UNITED STATES PATENT AND TRADEMARK OFFICE

APPLICATION NO.	FILING DATE	FIRST NAMED INVENTOR	ATTORNEY DOCKET NO.	CONFIRMATION NO.
09/683,354	12/18/2001	Joseph Neyman	neyman	3946

Office Action Summary

DETAILED ACTION

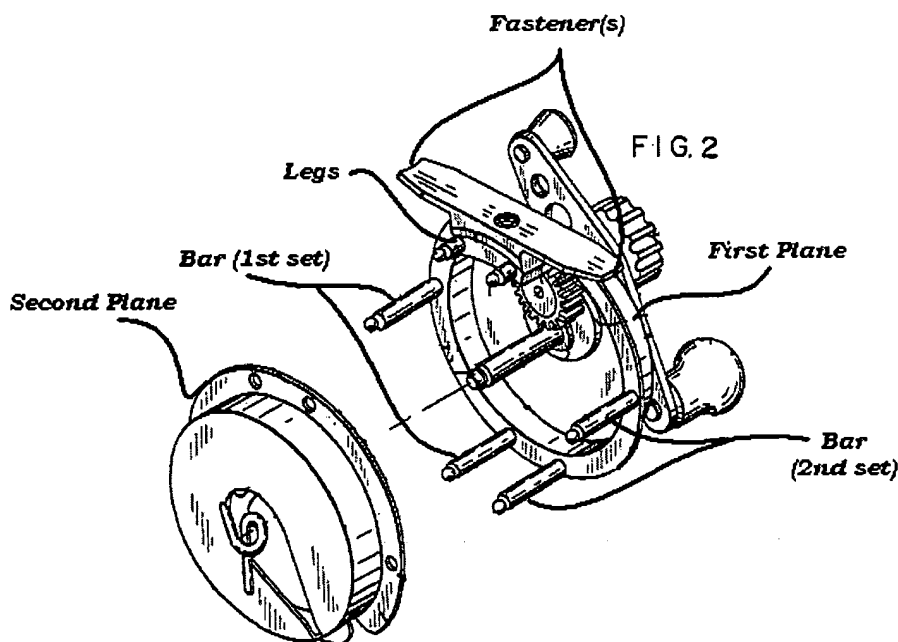
Dennison discloses a fishing line apparatus comprising a first plane, a set of bars communicating with the first plane, a series of legs, communicating with the first plane and a second plane communicating with the set of bars (see detail below); further comprising a second set of bars wherein the set of bars and second set of bars are disposed on opposite ends of said first and second plane (as the first and second set of bars are mirror images of each other, they are construed to be on opposite ends); wherein the set of bars creates a curvature at one end of the first and second plane, from the middle to the exterior, and the second set of bars creates a curvature at the second end of the first and second plane (i.e. the bars lie on an arcuate path) and comprising a hollow space between the first and second series of bars (seen in the

figure); further comprising a series of fasteners communicating with the series of legs (considered a series, i.e. more than one, in that each end of the fasteners communicate with separate structures of the reel seat assembly thereby producing two separate points of fastening); wherein the series of fasteners removably communicate with the fishing rod; further comprising indentations (i.e. the holes for receiving the first and second set of bars); wherein the fishing line can be wrapped around said first and second series of bars; wherein the series of bars is a means for wrapping a fishing line (and more generally a rope or thread) for storage and use. Regarding claim 15, while not stated in the disclosure, it is possible for a hook to be placed in the hollow space for storage.
